Subject: Request for vertical clearance waiver

The Washington State Department of Transportation is in the process of designing the widening of a railroad over-crossing near Grand Mound, where US-12 passes over the tracks of Tacoma Rail. The current vertical clearance provided between the top of rails and the bridge is 22'. The bridge was originally built in 1962, prior to the WUTC requirement in WAC 480-60-040 for minimum vertical clearances of 22.5'.

BRIDGE SHEET NO.	1
PRELIMINARY PLAN

RE: I-5 Grand Mound to Maytown Widening  
Proposed Bridge Widening

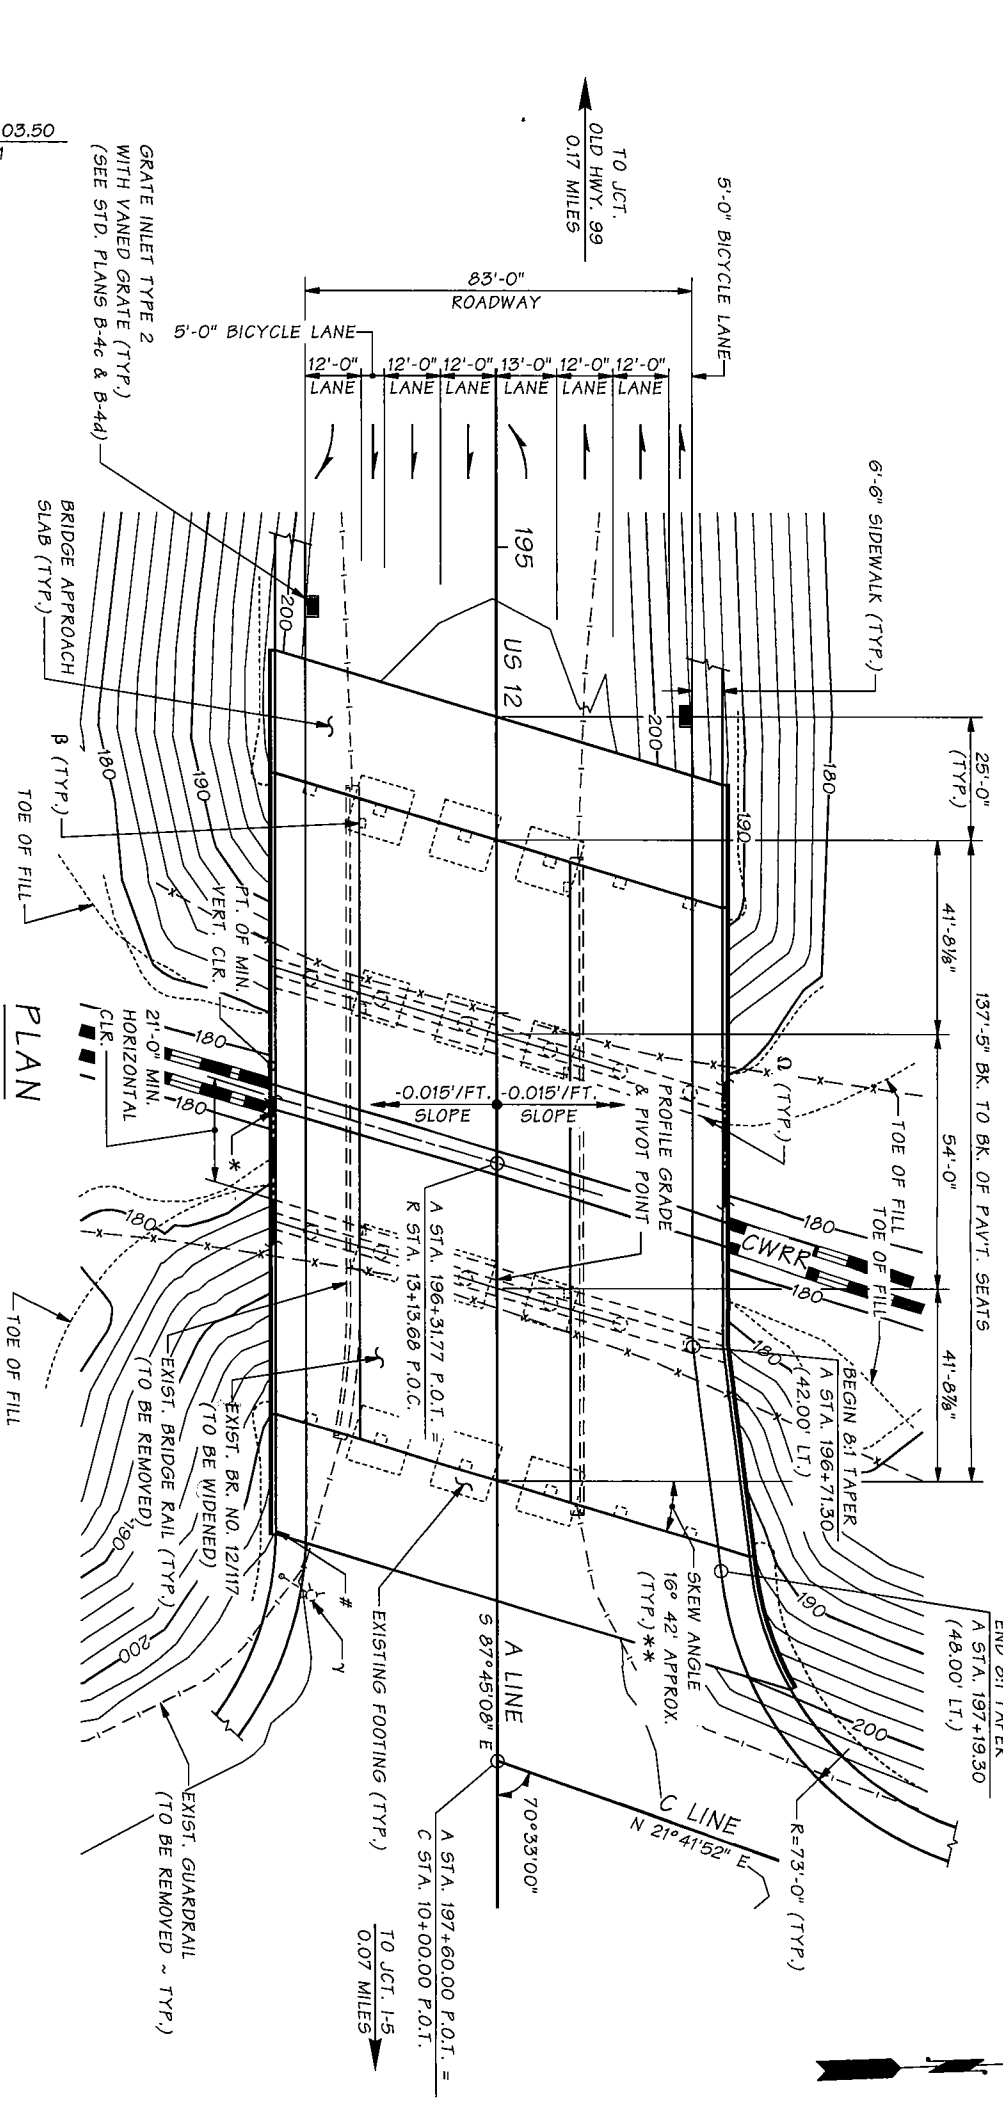
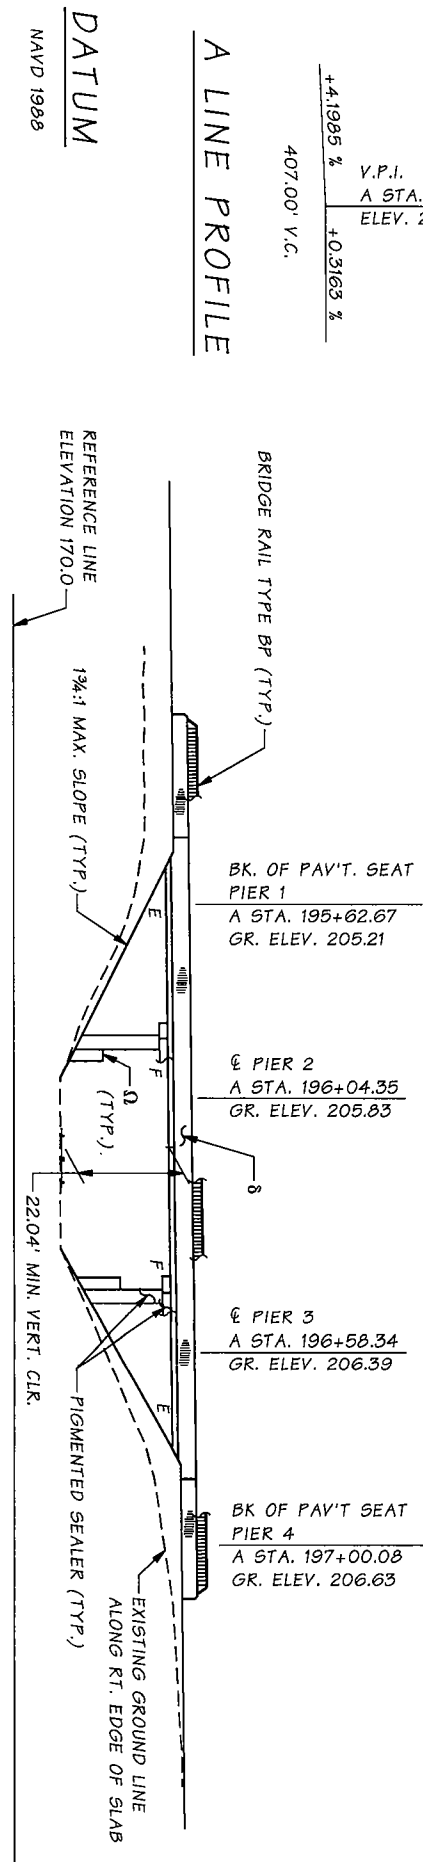
Since this is strictly a widening project, vertical clearance will not be significantly impacted<sup>1</sup>; however, the WSDOT Design Manual requires that railroad over-crossings being widened either meet the 22.5' standard or otherwise gain approval from WUTC. Whether this approval takes the form of a Commission order or a letter accepting the proposed clearance based on the project resulting in no change from the existing clearance is not specified. In addition, Tacoma Rail has provided us with a letter (enclosed) agreeing to a minimum clearance of 22'.

Please review the enclosed plans for the proposed bridge and determine a response as soon as possible. I am available to meet with you at any time to discuss this project or request. Please contact me at (360) 705-7271 if I can be of any assistance.

My understanding is that the final clearance will be no less than 22 feet from top of rail and that during construction the clearance will be no less than 19 feet above the rail.

This letter will act as the written permission required by WSDOT for these reduced clearances.
